Comment of the Oglethorpe Plan Coalition, Inc. on 114 West Bay Street, The Jones-Telfair Range

PROPOSED (EAST SIDE)

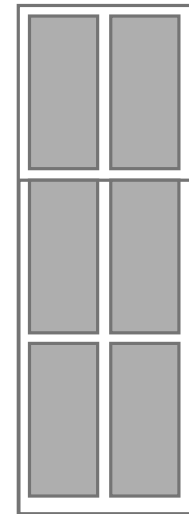
- Reversed: Four Over Two
- Not Recessed Sufficiently
- Sash (Muntin) Rail Too Thick

EXISTING (WEST SIDE)

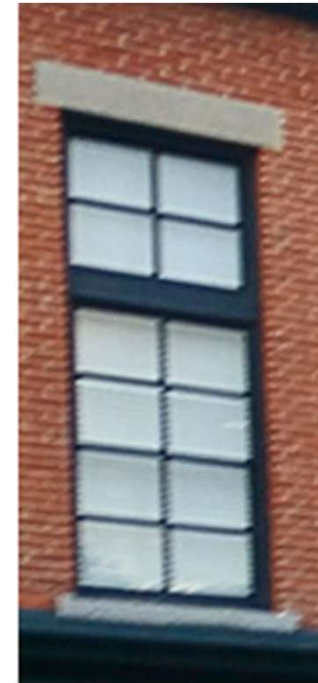
- No Relationship to the Historic Windows:
Thick Sash Rail, Four-Over-Eight
- Master Plan for Proper Window Replacement
Should Be Established
